**AGENDA  
PLANNING COMMISSION MEETING  
CITY OF SHOREVIEW**

**TO:** Planning Commission  
**FROM:** Aaron Sedey, Associate Planner  
**DATE:** May 17, 2018  
**SUBJECT:** Preliminary Plat (Major Subdivision), 4140 Hodgson Road, Sean Keatts, File No. 2689-18-09

Date: May 14, 2018  
To: Aaron Sedey, Associate Planner  
From: Tom Wesolowski, City Engineer  
Subject: Preliminary Plat and Plan Set – Subdivision – Revised 05-08-2018  
4140 Hodgson

**GRADING, DRAINAGE & ESC PLAN  
WHISTLER PINES C1.1**

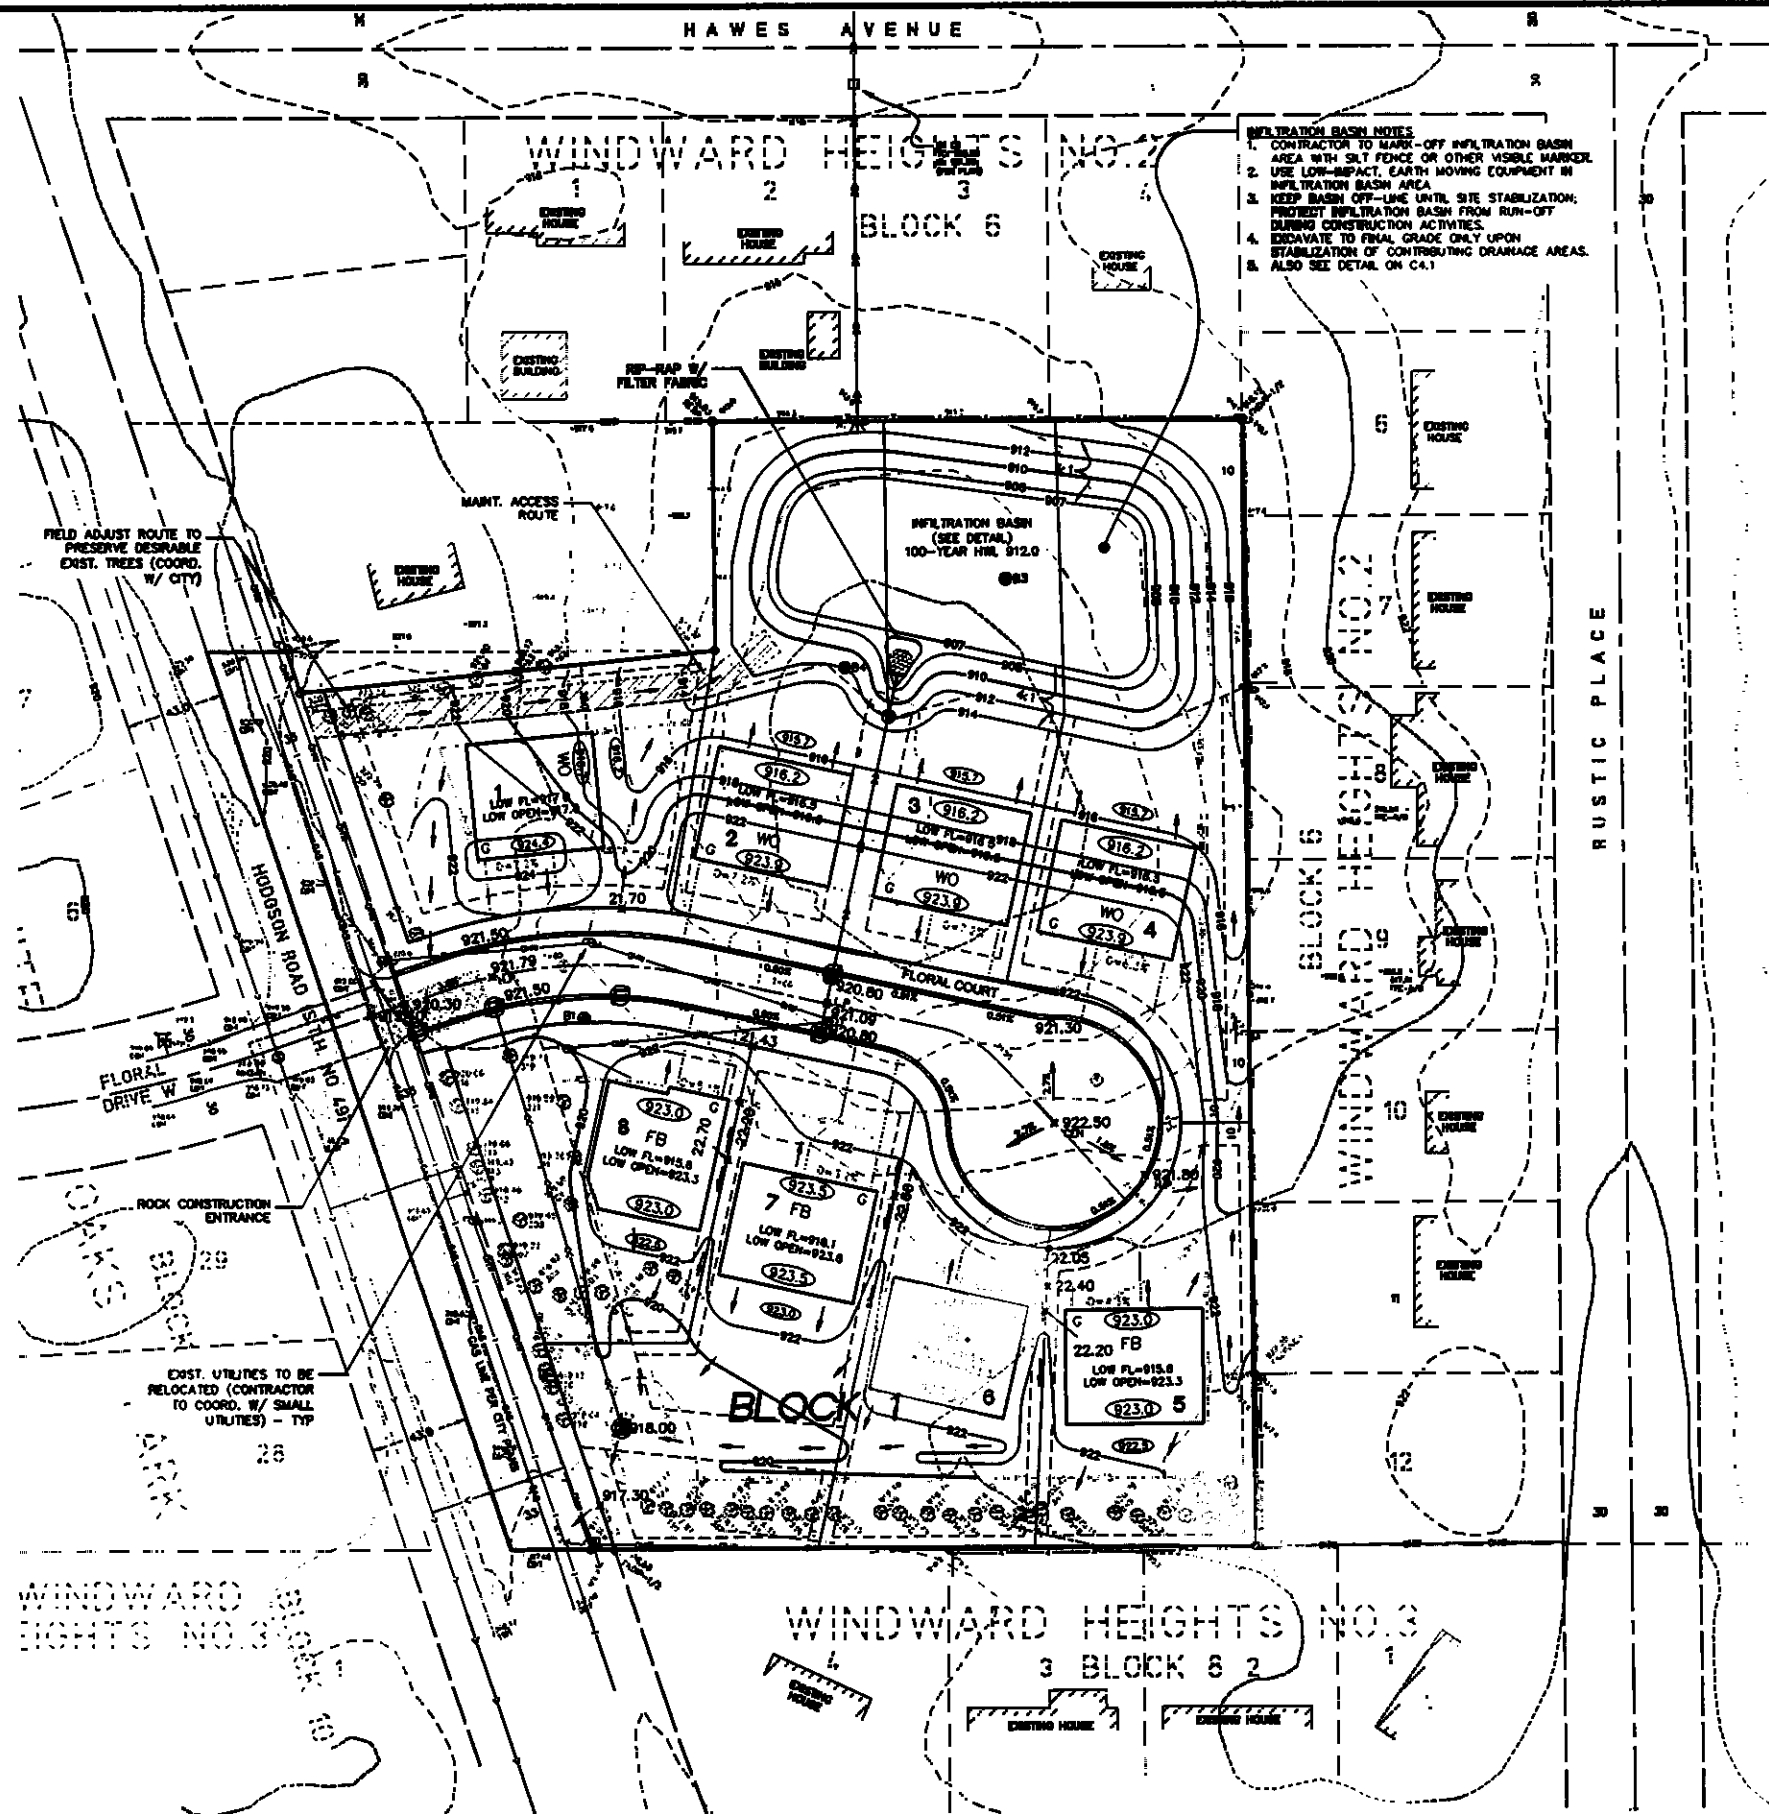
1. The developer has revised the stormwater management design to include additional underground infiltration along the west side of the site and also an underground outlet pipe from the proposed infiltration basin located on the north side of the property, that would connect to the existing City stormwater collection system on Hawes Avenue. The revisions to the design were based on a meeting between the developer, the developer's engineer, City staff, and staff from the Ramsey-Washington Metro Watershed District (RWMWD). The design does meet or exceed the requirements of the City's Surface Water Management Plan requirements. The design must also meet the requirements of the RWMWD and a permit is required.

2. Final grading, drainage and erosion control plans are subject to the review and approval by the Public Works Director prior to approval of any permits or the Final Plat. Concerns identified by the City Engineer shall be addressed with the Final Plat submittal.

**CURBING & PAVING PLAN  
WHISTLER PINES**

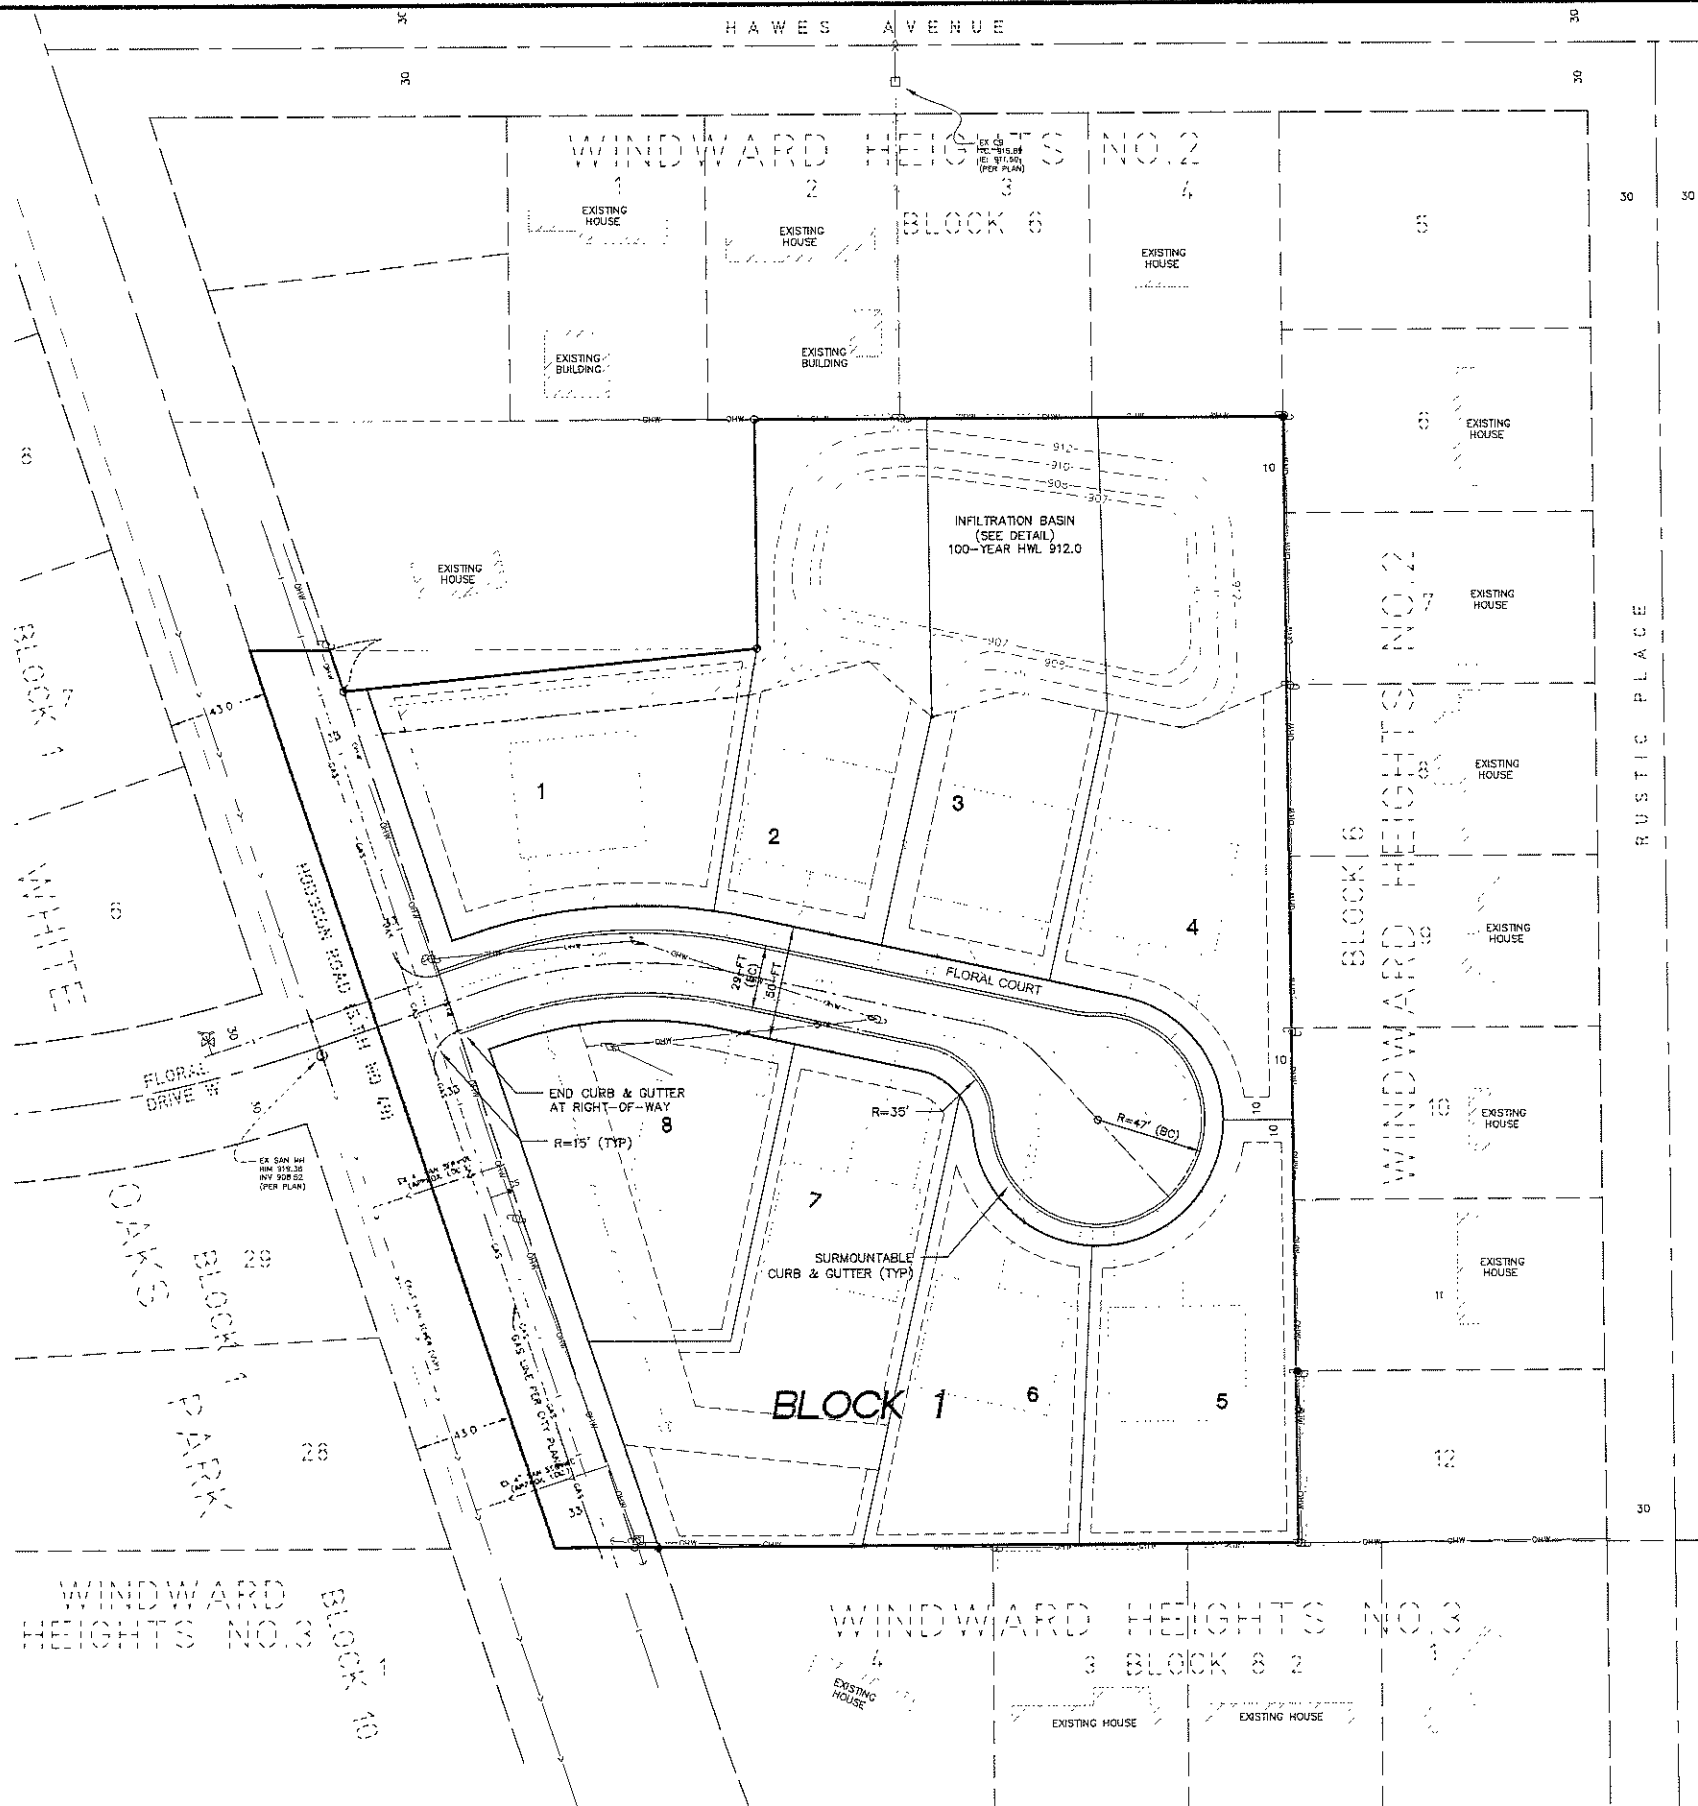
- c. Surmountable concrete curb gutter is an acceptable style and is consistent with similar neighborhoods in the City. A detail of the style of surmountable curb and gutter required by the City will be supplied to the engineer working with the developer.
